UNITED STATES PATENT AND TRADEMARK OFFICE

APPLICATION NO.	FILING DATE	FIRST NAMED INVENTOR	ATTORNEY DOCKET NO.	CONFIRMATION NO.
10/709,661	05/20/2004	Bertil Jonsson	07589.0175.PCUS00	3039

Office Action Summary

DETAILED ACTION

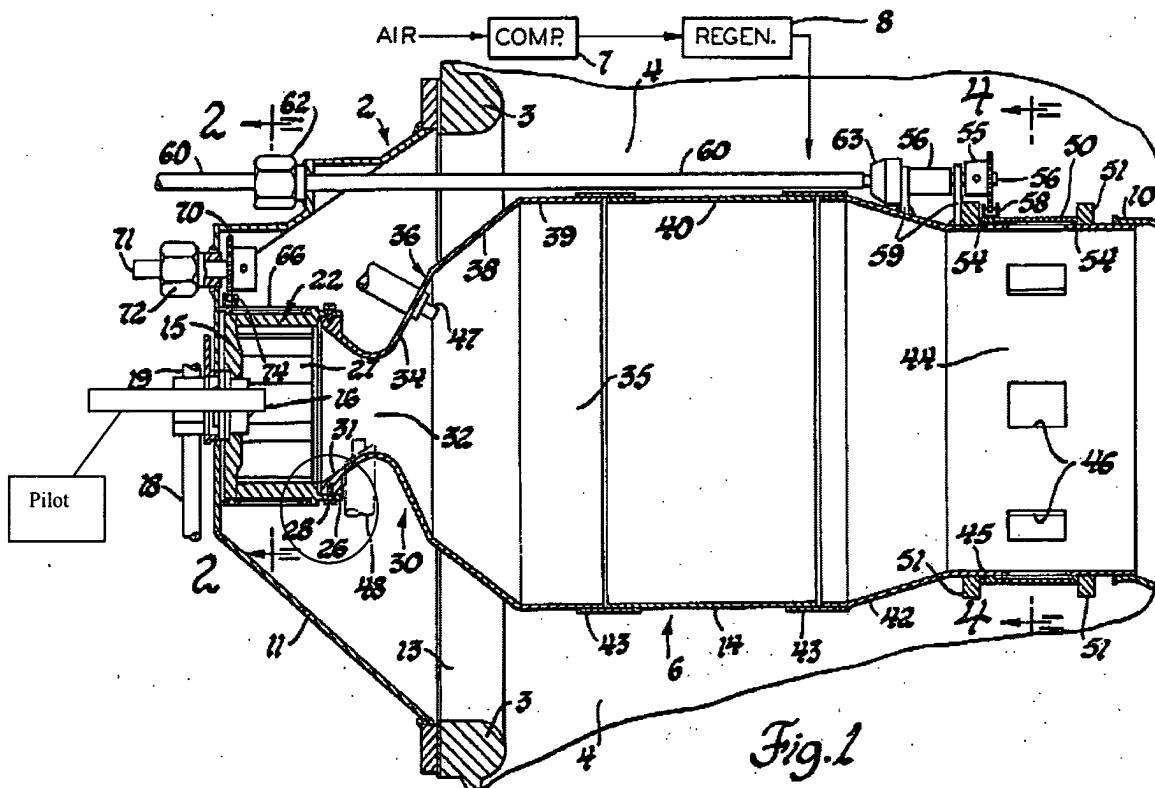
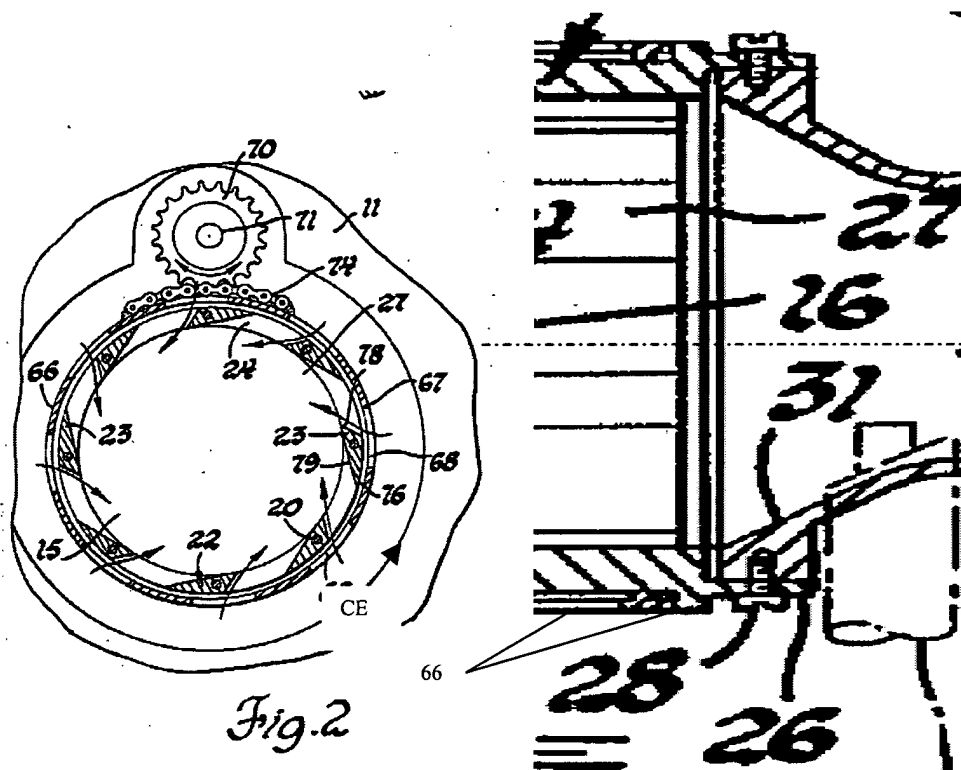
With respect to claim 1, **Cornelius** teaches a device for a combustion chamber (2) in a gas turbine for controlling the intake of gas to a combustion zone of the combustion chamber, said device comprising: a control element CE arranged outside the combustion chamber, said control element further comprising a cover means (66) for covering at least a first inlet 24 to the combustion zone, said cover means 66 being displaceable relative to the combustion chamber, and a support means (31) for the control element which is connected to the cover means 66, said support means (31) being accommodated in a structure (26) at a rear of the combustion chamber. See particularly **Figures 1, 2** of **Cornelius**.

With respect to claim 2, **Cornelius** teaches that the structure 26 in which the support means 31 is accommodated forms at least part of the cover means 66. See sectional view of **Figure 1** above.

With respect to claim 3, **Cornelius** teaches that the structure 26 in which the support means 31 is accommodated is predominately concentrically oriented with a centerline of the combustion chamber. See sectional view of **Figure 1** above.

With respect to claim 4, **Cornelius** teaches that the structure 26 in which the support means 31 is accommodated is radially oriented outside a pilot distributor (not shown but inherent feature in a combustion chamber) to the combustion chamber. See particularly **Figure 1** of **Cornelius**.

With respect to claim 6, **Cornelius** teaches the structure 26 in which the support means 31 is accommodated has a circular cross-sectional shape. See particularly **Figure 1** of **Cornelius**.

With respect to claim 7, **Cornelius** teaches that the cover means 66 has at least one recess 68 extending predominantly in a radial direction through a wall thereof. See particularly **Figure 2** of **Cornelius**.

With respect to claim 8, **Cornelius** teaches the recess 68 in the cover means 66 is arranged together with the first inlet 24 to the combustion chamber thereby establishing a through-duct for gas from a location outside the combustion chamber to a location inside the combustion chamber. See particularly **Figure 2** of **Cornelius**.

With respect to claim 11, **Cornelius** teaches that the cover means 66 is ring-shaped with recess 68 extending through the wall of the ring. See particularly **Figure 2** of **Cornelius**.

With respect to claim 13, **Cornelius** teaches that the support means 31 and the cover mean 66 are fixed to one another (through the structure 26 and bolts 28). See particularly **Figure 1** of **Cornelius**.

With respect to claim 14, **Cornelius** teaches that the control element is rotatable relative to the structure. See particularly **Figure 1** of **Cornelius**.

With respect to claim 15, **Cornelius** teaches that the cover means 66 is arranged at a greater radial distance from a central axis through the control element than is the means of support 31. See particularly **Figure 1** of **Cornelius**.

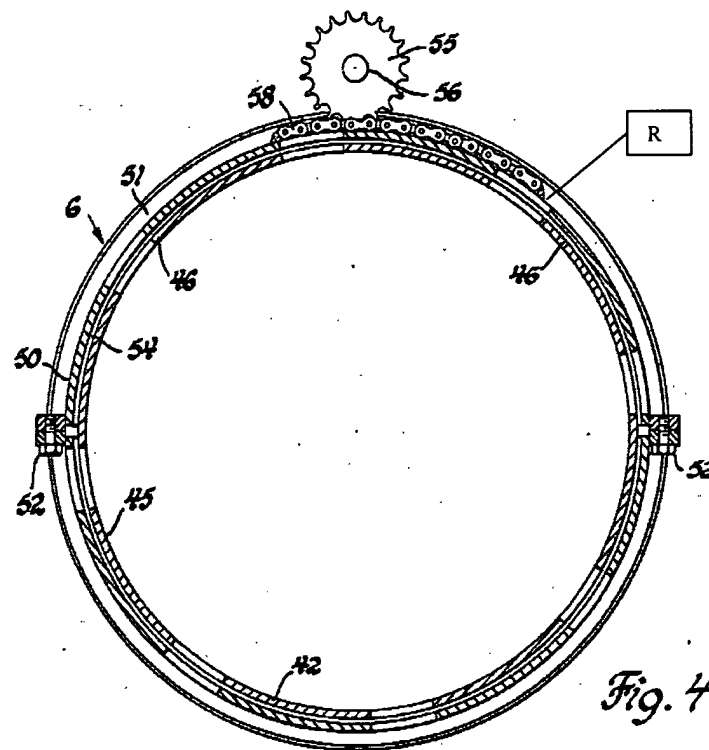
With respect to claim 12, **Cornelius** teaches that the cover means 66 is rotatable in relation to the combustion chamber wall 22. See particularly **Figures 2, 3** of **Cornelius**.

With respect to claim 17, **Cornelius** teaches that the control element further comprises a second cover means (50) configured to cover at least a second inlet to the combustion zone, the second inlet being arranged at a distance from the first inlet in the longitudinal direction of the combustion chamber. See particularly **Figures 1, 4** of **Cornelius**.

With respect to claim 18, **Cornelius** teaches that the second cover means 50 has at least one recess R which extends at least largely in a radial direction through the wall thereof. See particularly **Figure 4** of **Cornelius**.

With respect to claim 19, **Cornelius** teaches that the at least one recess R in the second cover means 50 is arranged, together with the second inlet 46 to the combustion chamber, to form a through-duct for gas from a location outside the combustion chamber to a location inside the combustion chamber. See particularly **Figure 4** of **Cornelius**.

With respect to claim 20, **Cornelius** teaches that the second cover means 50 is ring shaped and the recess R extends through a wall of the ring. See particularly **Figure 4** of **Cornelius**.

With respect to claim 21, **Cornelius** teaches that the second cover means 50 is rotatable relative to the combustion chamber wall 45. See particularly **Figure 4** of **Cornelius**.

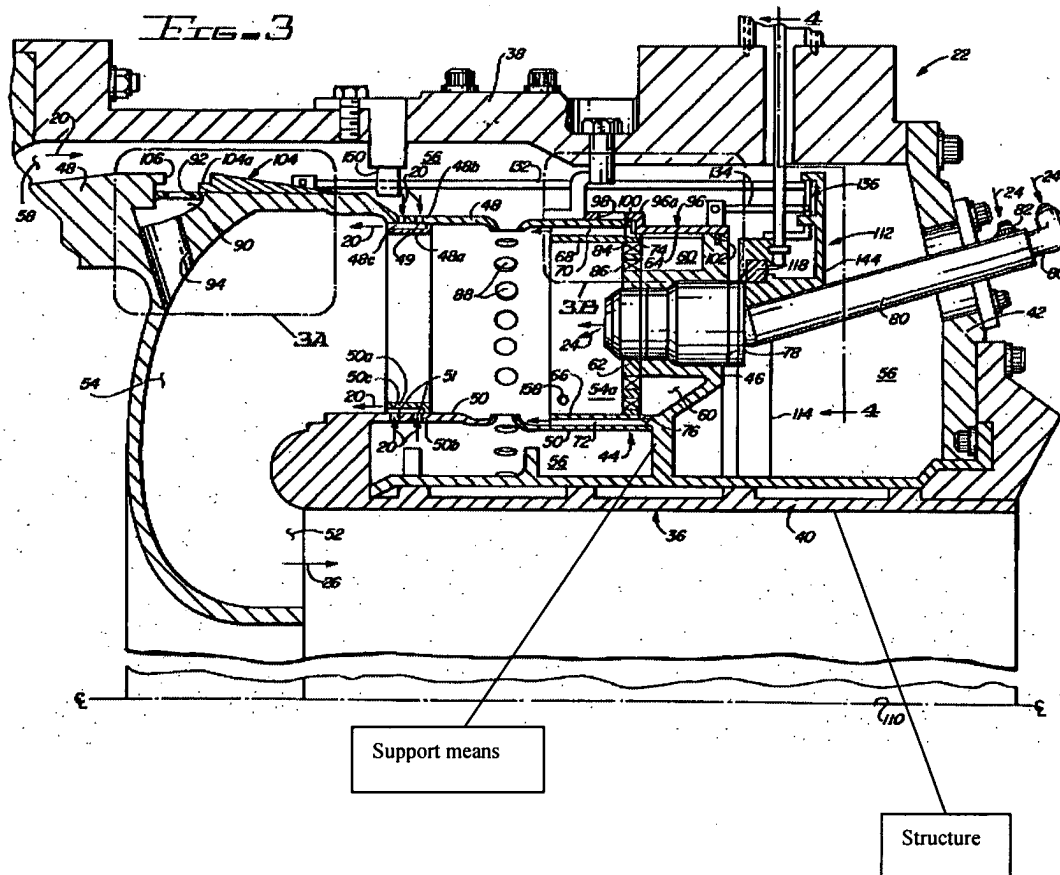
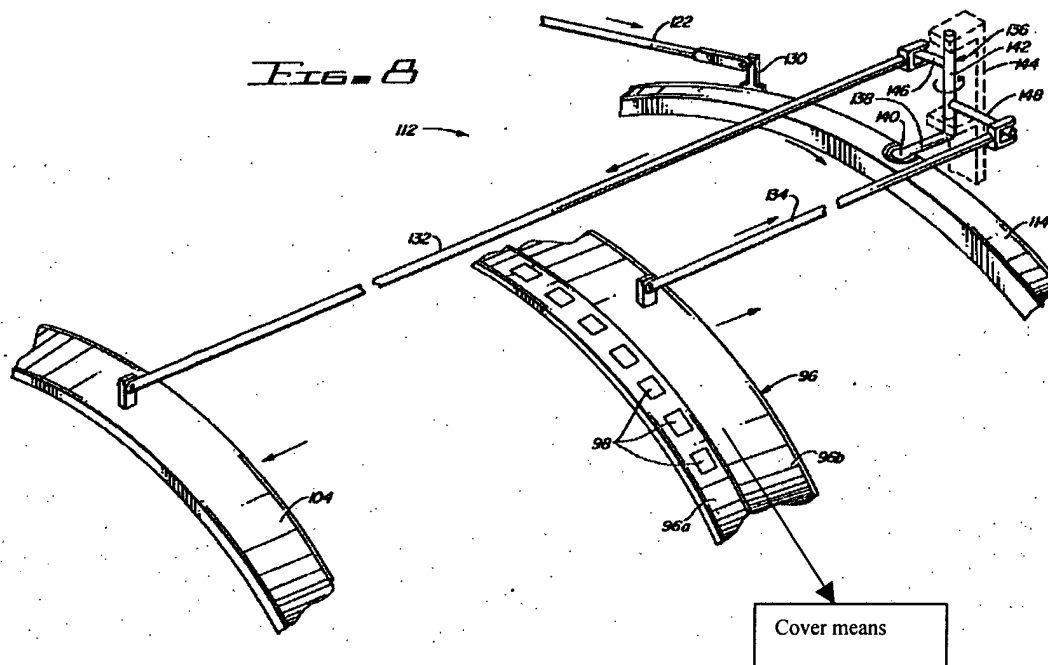
11. The prior art made of record and not relied upon is considered pertinent to applicant's disclosure. U.S. reference 4,532,762 can be used to reject at least claim 1 under 35 U.S.C. 102 (b). See particularly Figures 3, 8 below.
